SOIL & EROSION CONTROL PLAN
1701 DISCIPLE DRIVE
JONESBORO, ARKANSAS
FOR
JOURNEY CHURCH

JOB NO.: 119042
SHEET NUMBER
5 of 6

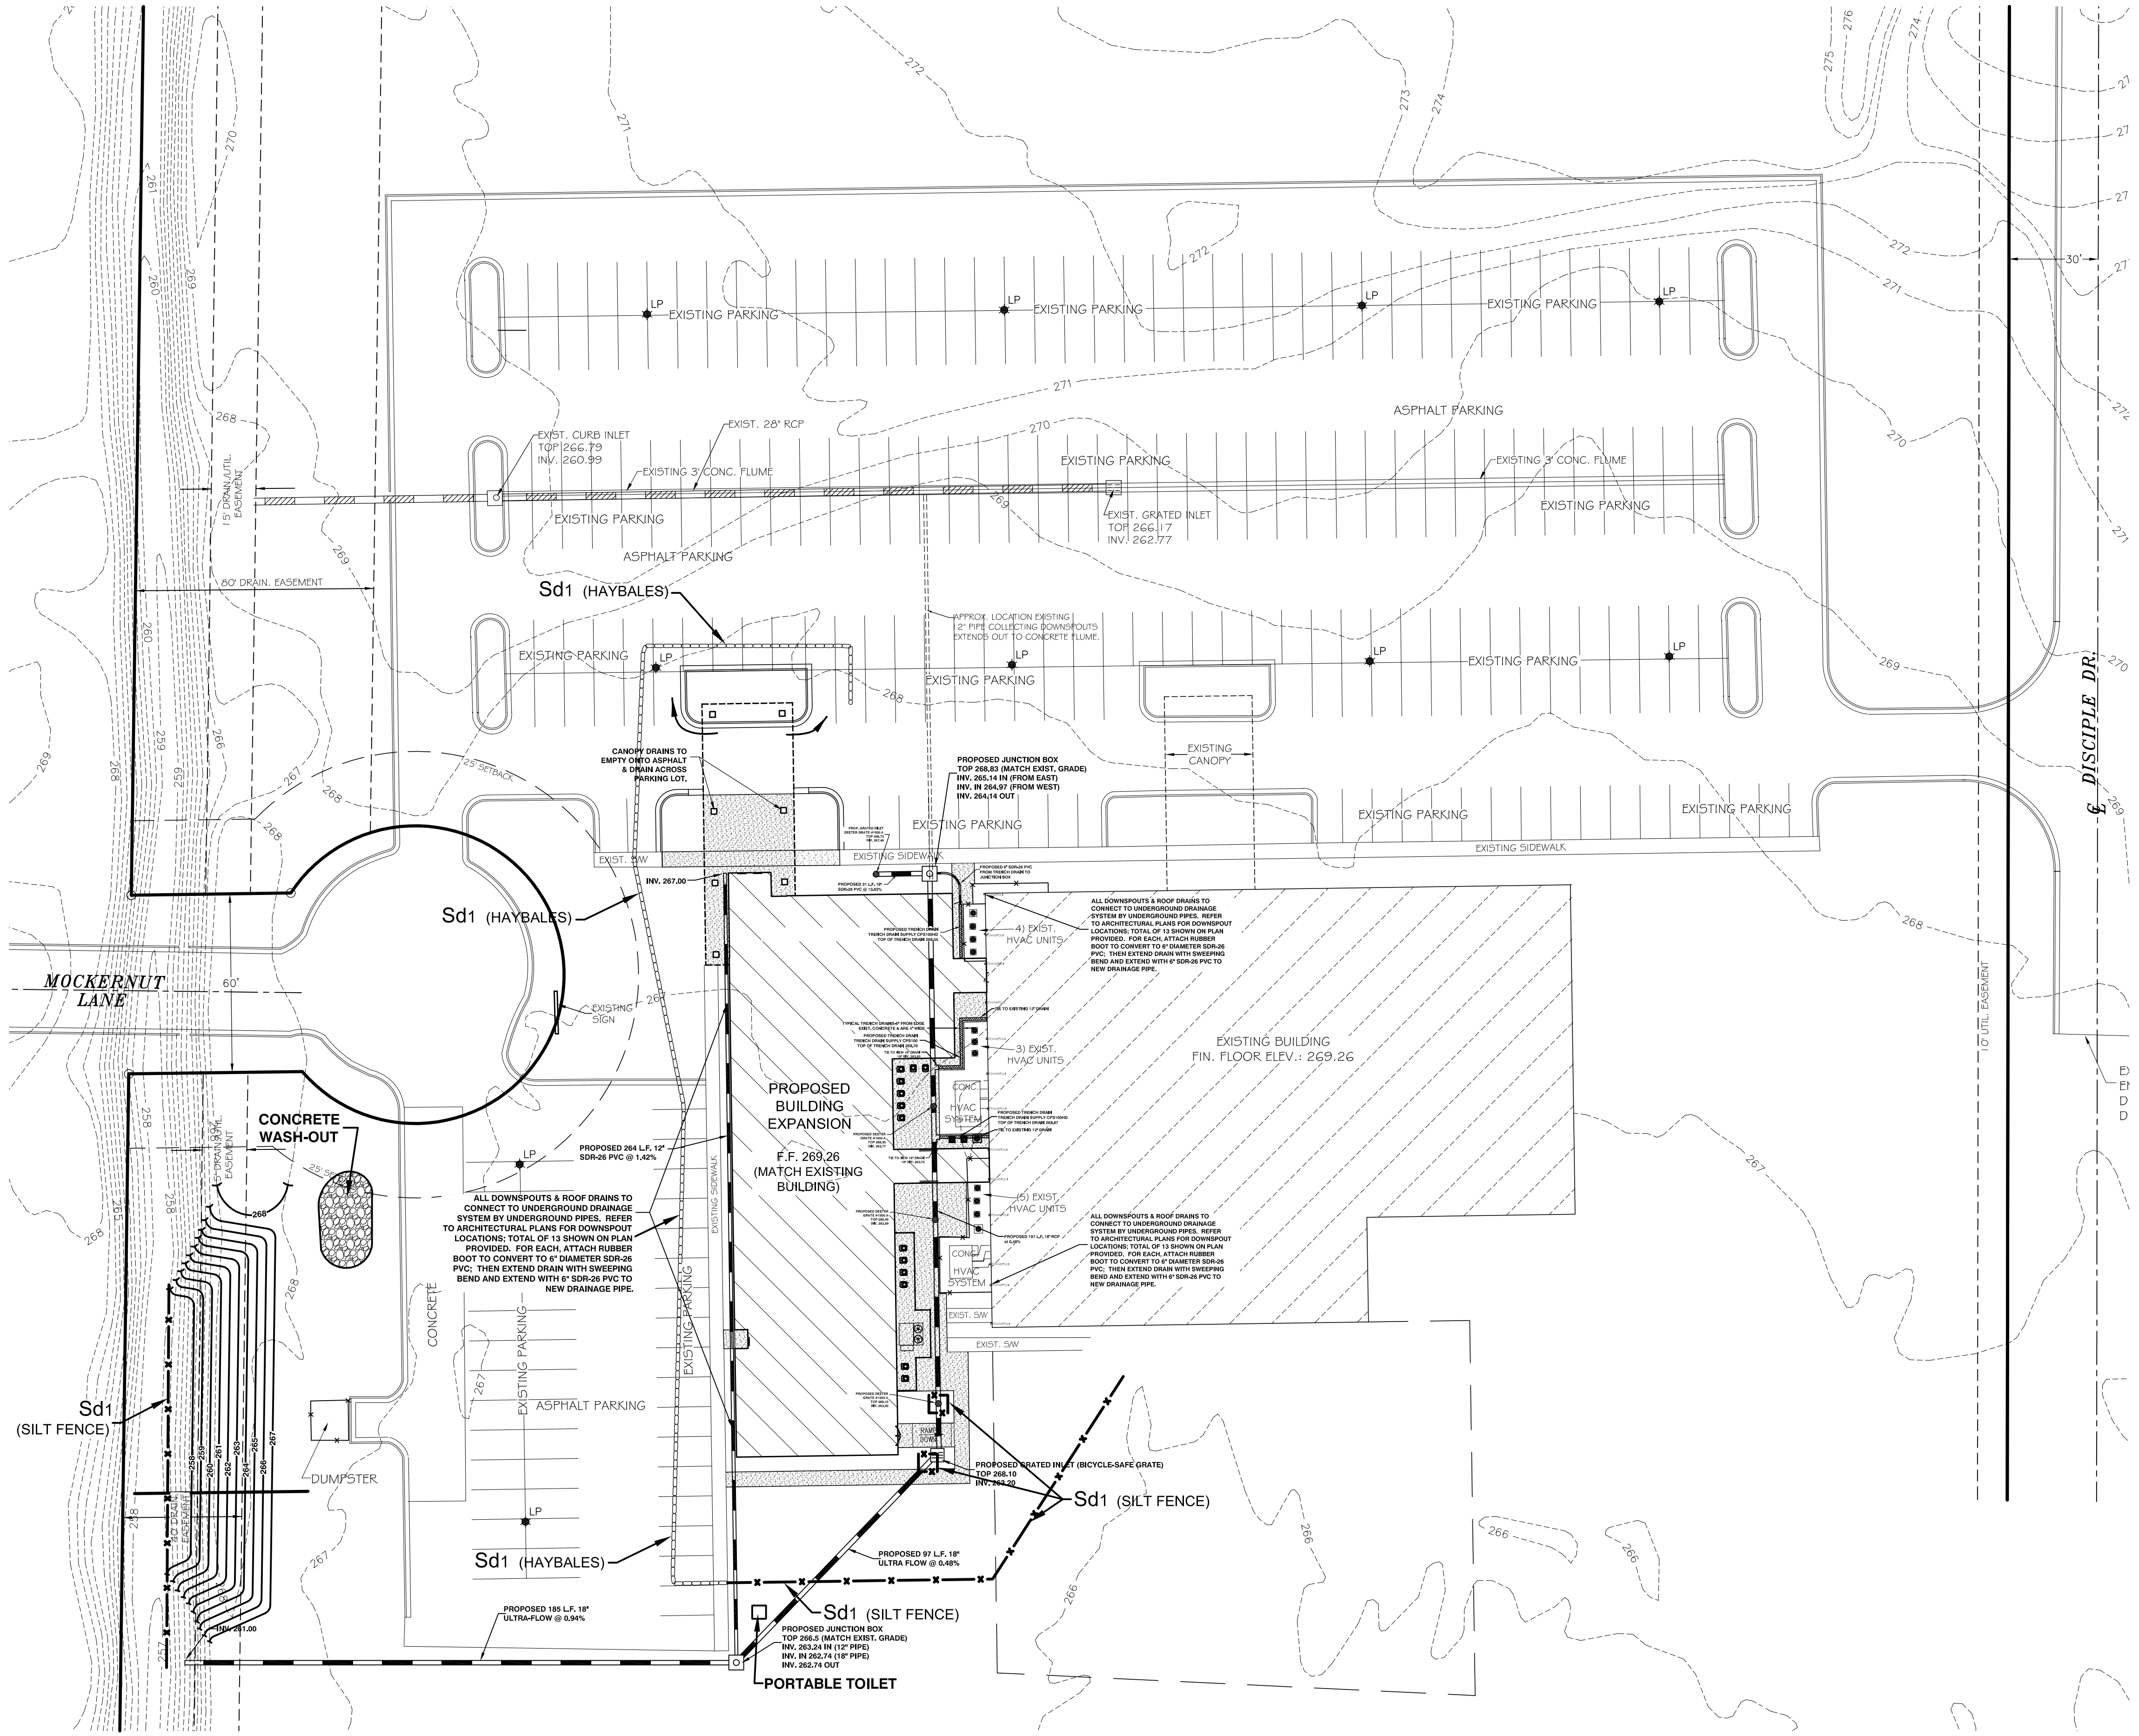
REVISED 8-05-19: PART OF ADDENDUM NO. 2
SILT FENCE ADDED
REVISED 7-31-19: PART OF ADDENDUM NO. 1
ADDITIONAL TOPO AND GRADING
REVISED 7-24-19: LINES ADDED - PART OF ADDENDUM NO. 1
